<b>Form 504</b>	
U. S. DEPARTMENT OF COMMERCE	
COAST AND GEODETIC SURVEY	
<b>DESCRIPTIVE REPORT</b>	
Type of Survey <u>SHORELINE (Photogrammetric)</u>	
Field No. ....	Office No. <u>T-11810</u>
<b>LOCALITY</b>	
State .....	<u>Mississippi</u>
General locality .....	<u>Mississippi Sound</u>
Locality .....	<u>Gulfport Harbor</u>
<u>19 66</u> - 1968	
<b>CHIEF OF PARTY</b>	
<u>J. Bull, Director, Atlantic Marine Center</u>	
<b>LIBRARY &amp; ARCHIVES</b>	
DATE .....

SUMMARY TO ACCOMPANY  
DESCRIPTIVE REPORT T-11810

REVIEW REPORT T-11810  
SHORELINE  
AUGUST 1968

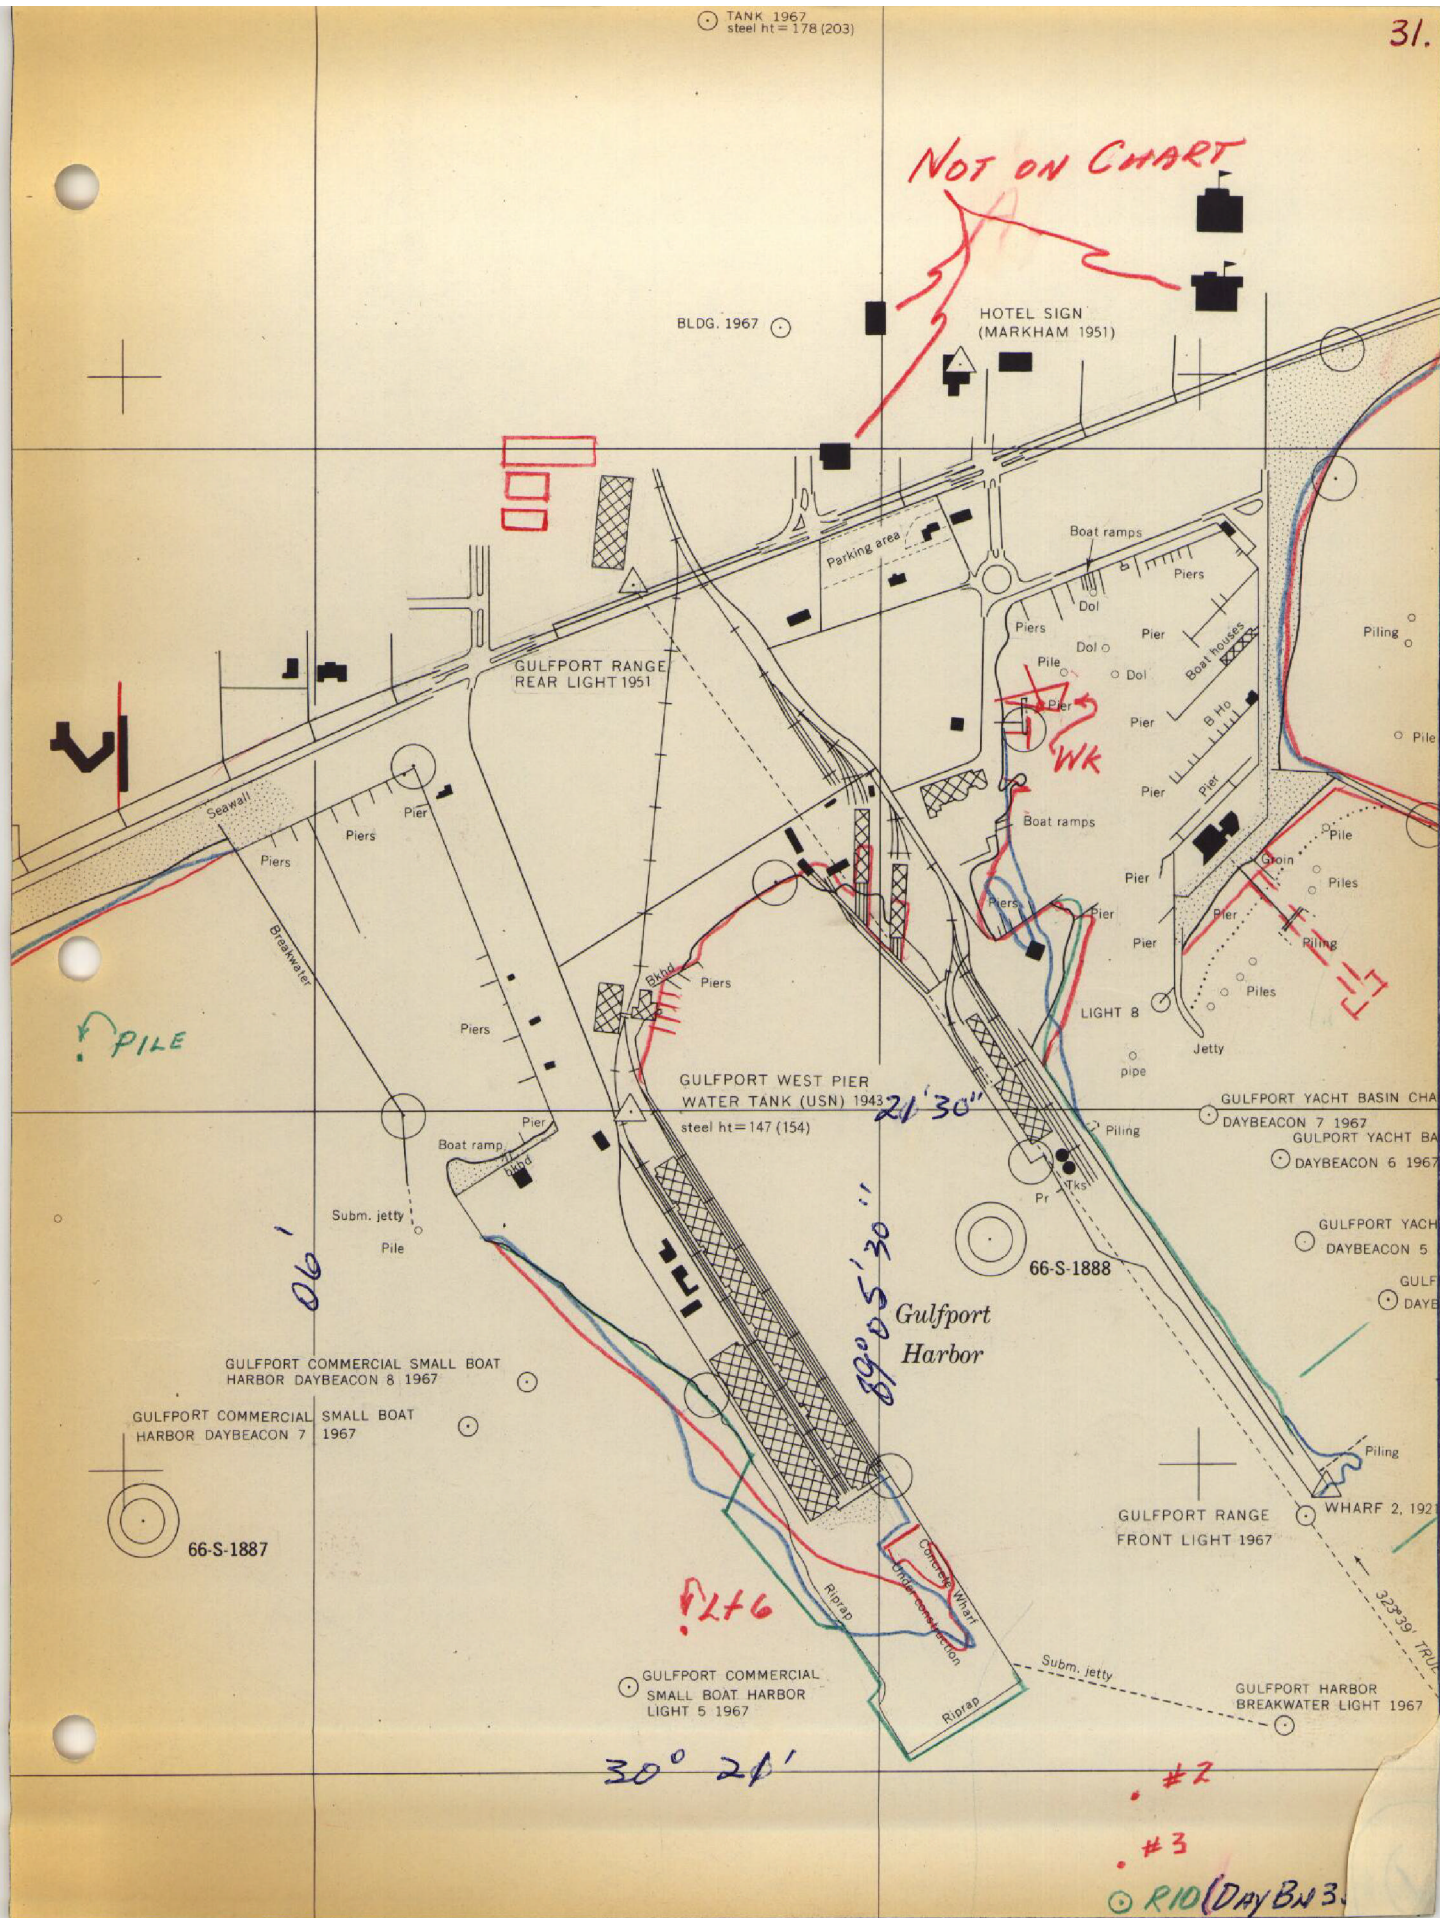
(a) The wreck inside the yacht basin (page 31) at latitude  $30^{\circ} 21.8'$ , longitude  $89^{\circ} 05.35'$  is not visible on the photographs, was not found by the field editor, and not found by the hydrographic party.

(c) Some small piers in Gulfport Harbor (page 31) near latitude  $30^{\circ} 21.56'$ , longitude  $89^{\circ} 05.7'$  are not visible on the photographs and were not noted by the field editor.

(d) The pier in ruins on the chart (page 31) near latitude  $30^{\circ} 21.6'$ , longitude  $89^{\circ} 05.11'$ , has been rebuilt and is shown as it is on 1968 Field Edit Cronaflex #2 of 2.

(g) The building near latitude  $30^{\circ} 22'$ , longitude  $89^{\circ} 06.6'$  (page 30) on the chart does not exist on the 1966 photographs.

BLDG ON 876 SC  
BUT NO BUILDING HERE  
ON PHOTOGRAPHS.

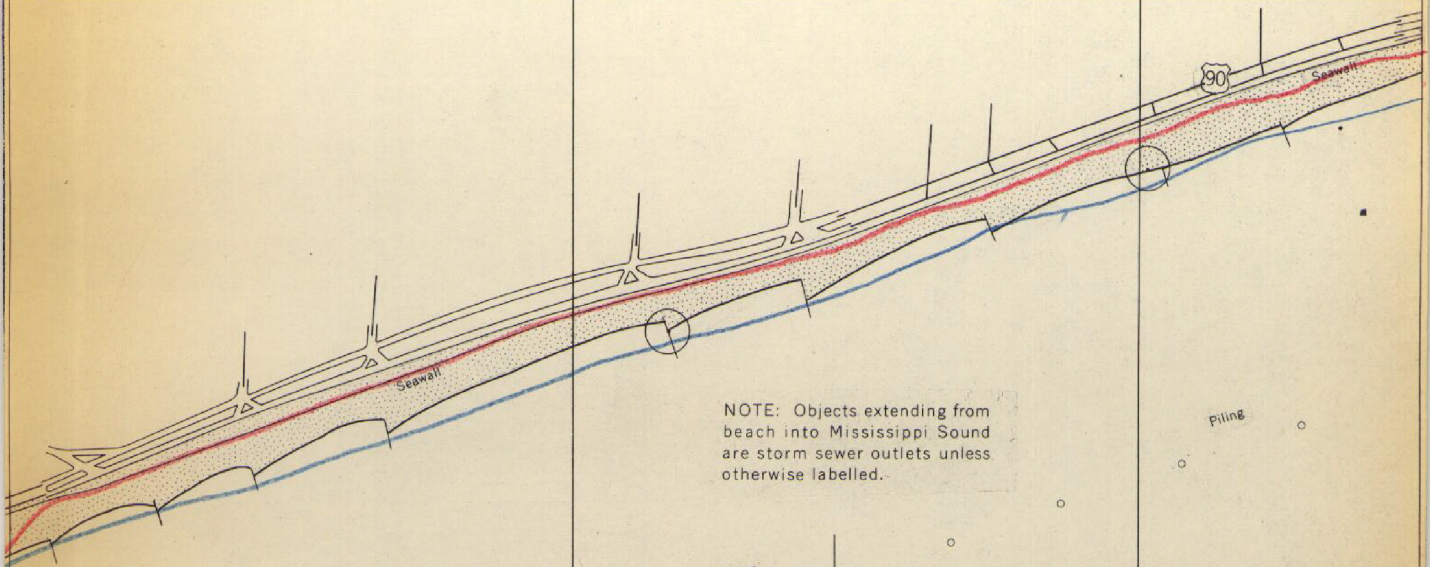
(c) No note of the cable area (on page 32) was made by the field editor.

(e) Three piles near latitude  $30^{\circ} 21.9''$ , longitude  $89^{\circ} 04.8'$  are not visible on the photographs and were not noted by the field editor.

Letty  
Pier ruins  
Sunken on 876 SC (but awash by field editor)  
04'30"
